River City Phase 4

July 26, 2017

Review Stage: Construction Documents

WEST DON LANDS – RIVER CITY PHASE 4
DESIGN REVIEW PANEL 4 – JULY 26 2017

Harris Square Screen

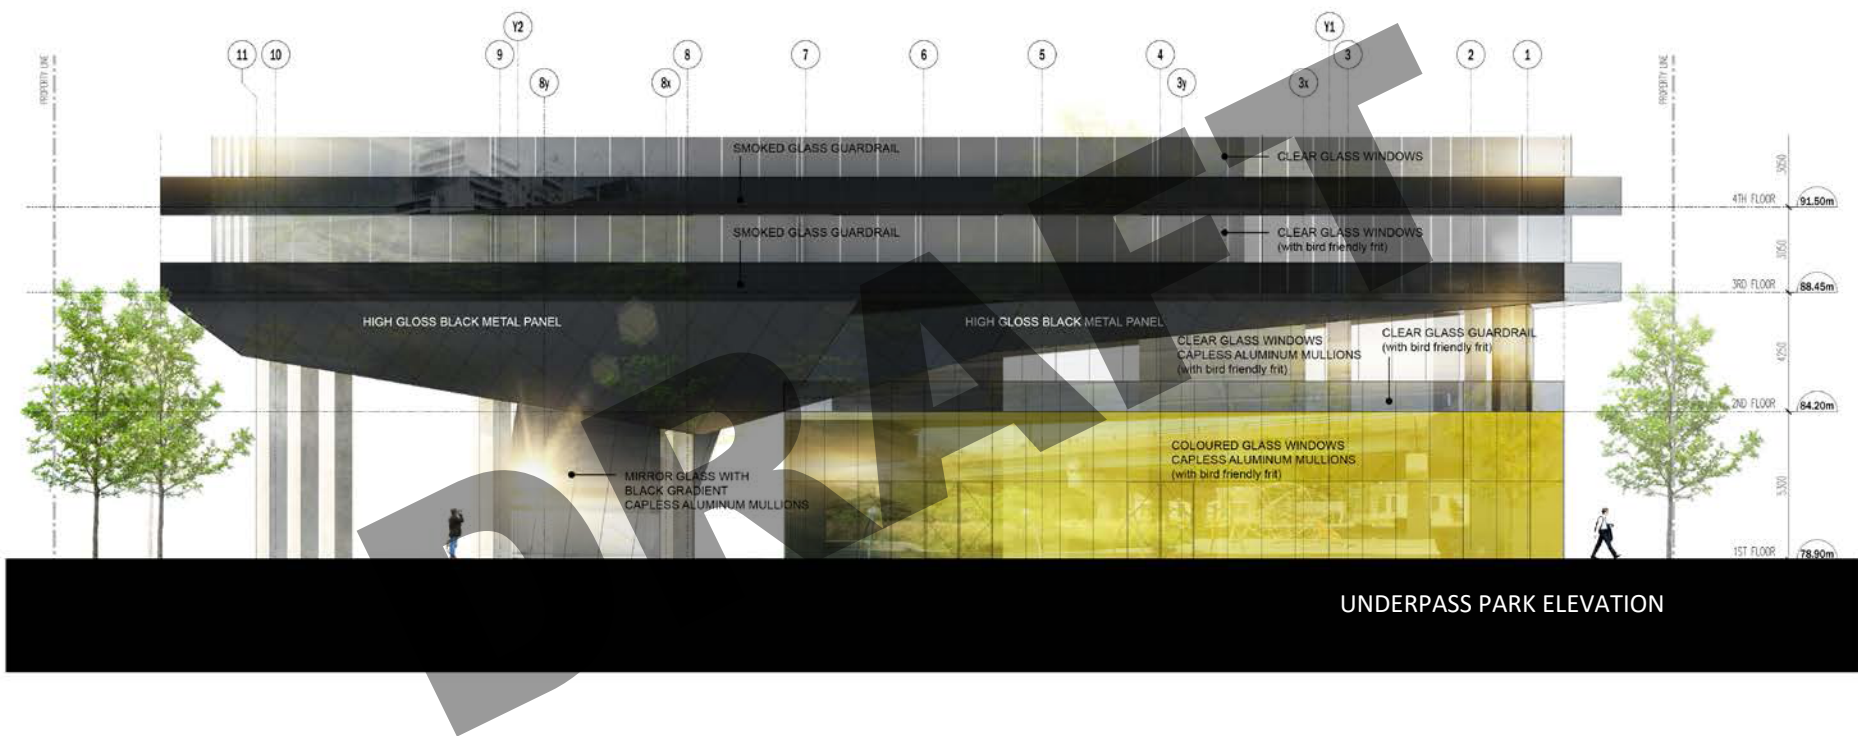
- Requested screen to block garbage and loading area from Underpass Park (has been incorporated in SPA final submission)

6-8" High screen, approx 78' long

Curtain wall framed opaque grey glass

Idea to subtly reflect park and surrounding colours with a polished material. Matches with concrete as if it were a polished version of it
Covers extents of garbage, loading and gas meter at edge of site

SLOPED SOFFIT DETAIL AT CURTAIN WALL
AND BALCONY

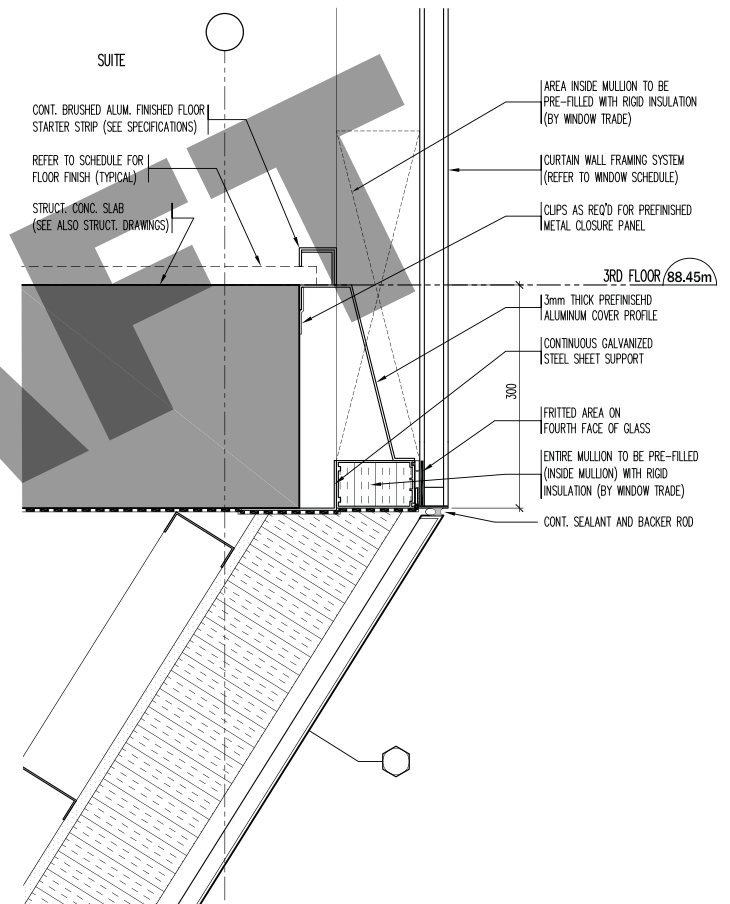
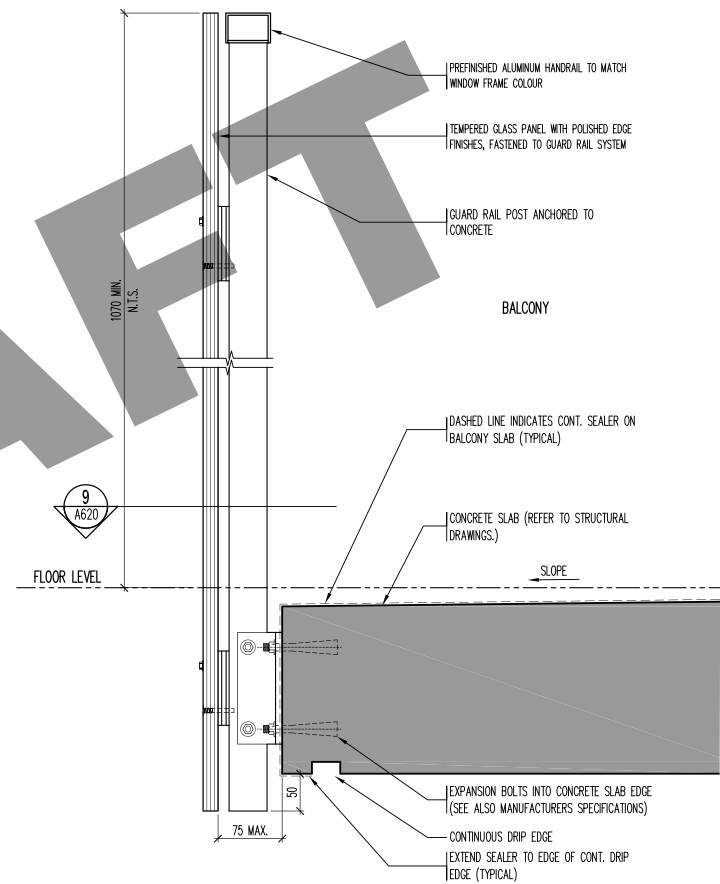
- Detailed Design for the landscape
- Updates on the stairwell detailing
- Materiality and detailing of the soffit and interface with the balcony
- Appropriateness of the materials

PUBLIC STAIR WELL CLADDING DETAIL

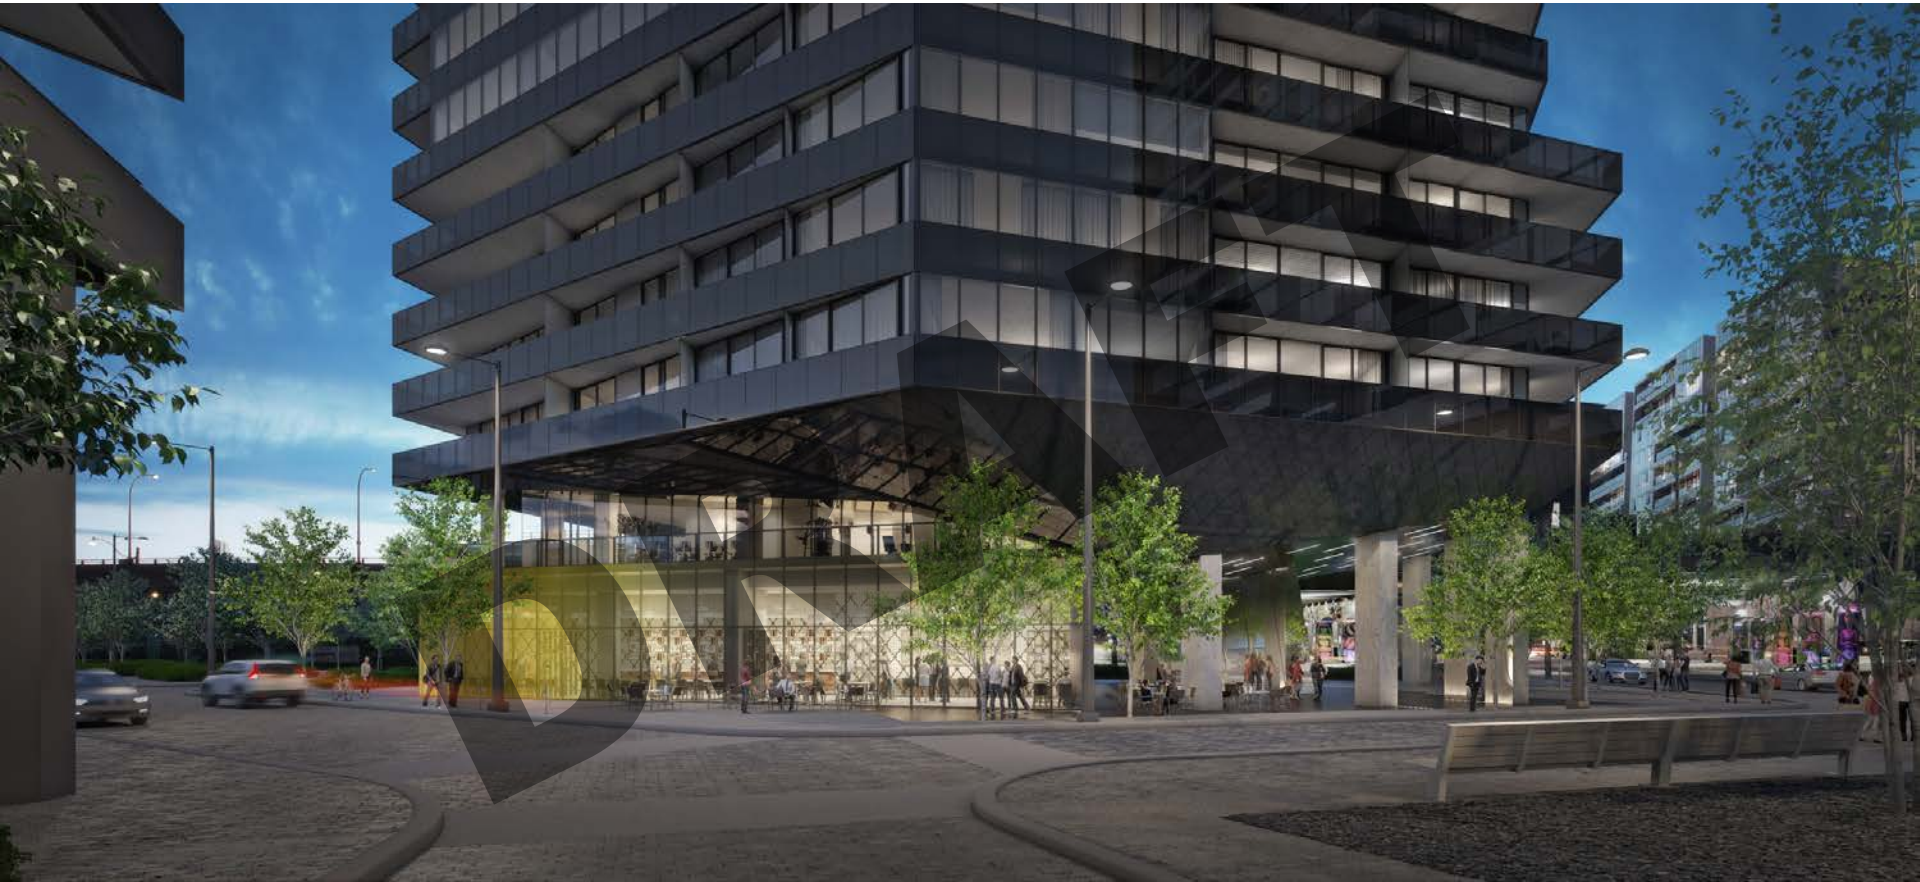
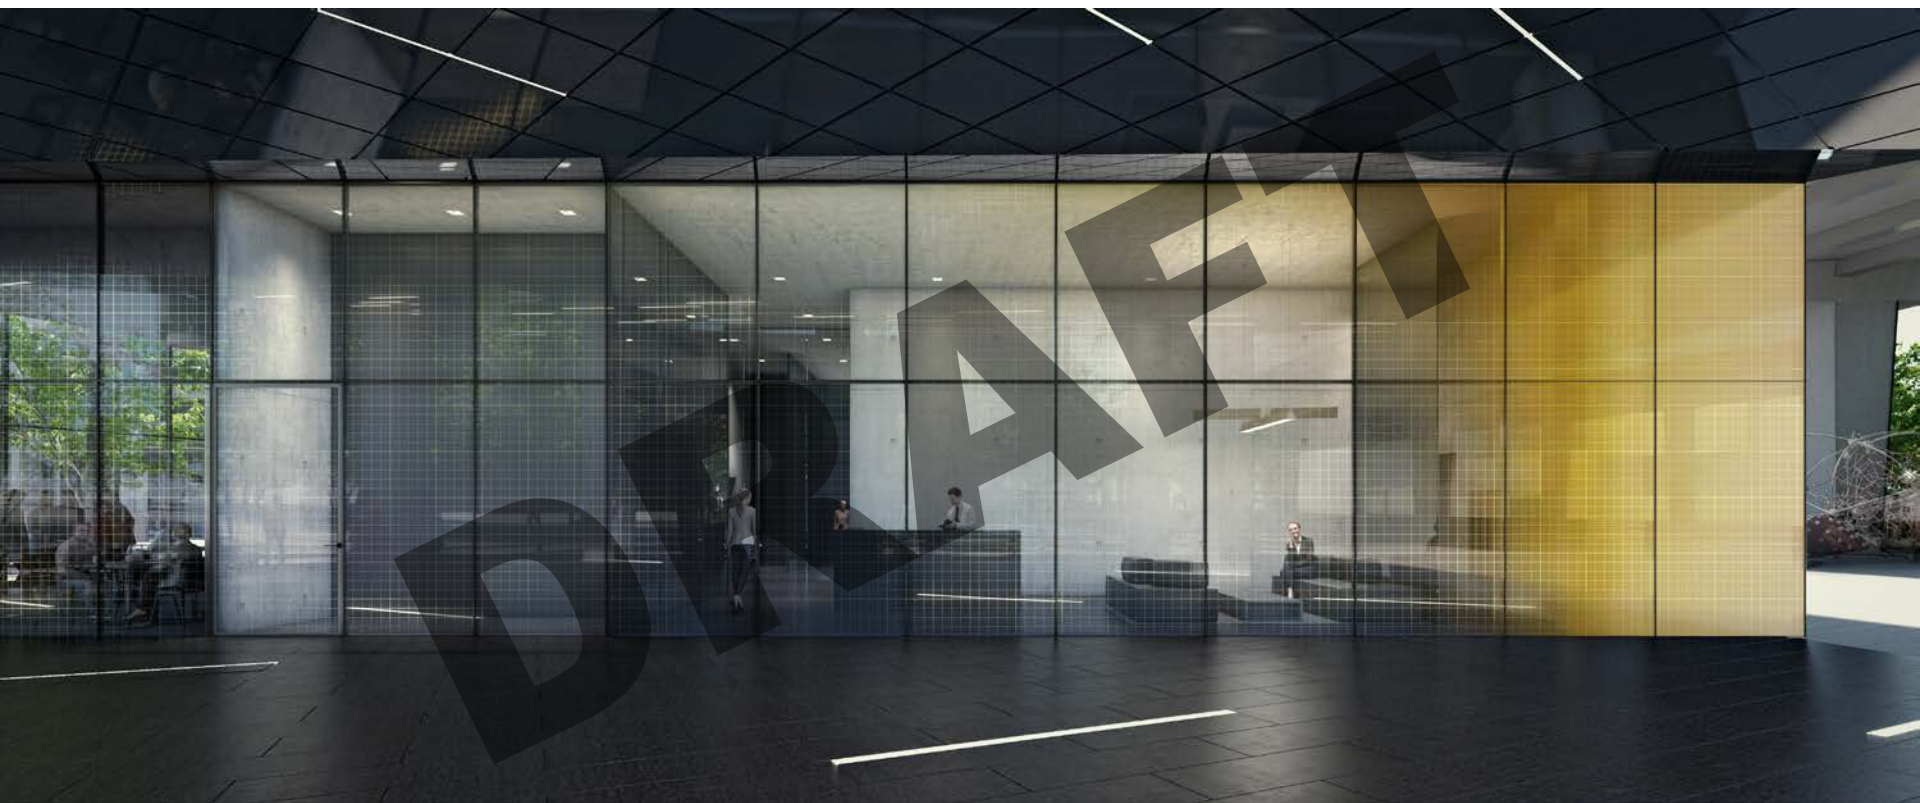
- The type of retail on the ground floor, potential seating and other program elements will be critical to the activation of the public realm space.
- Explore the possibility of flexibility in combining units.
- The cladding of the public stairwell needs to be explored in further detail to ensure that it becomes something positive, such as public art.
- The treatment to the underside of the soffit is an important detail as it will be visible from the pedestrian level.
- The relationship and transition between the soffits and the balconies is critical.
- The EUI for this building seems high, consider integrating additional sustainability measures.

SMOKED GLASS GUARD

HIGH GLOSS BLACK METAL PANEL

GRADIENT FROM SOLID
BLACK TO MIRROR

MIRROR GLASS WITH
BLACK GRADIENT
CAPLESS ALUMINUM MULLIONS
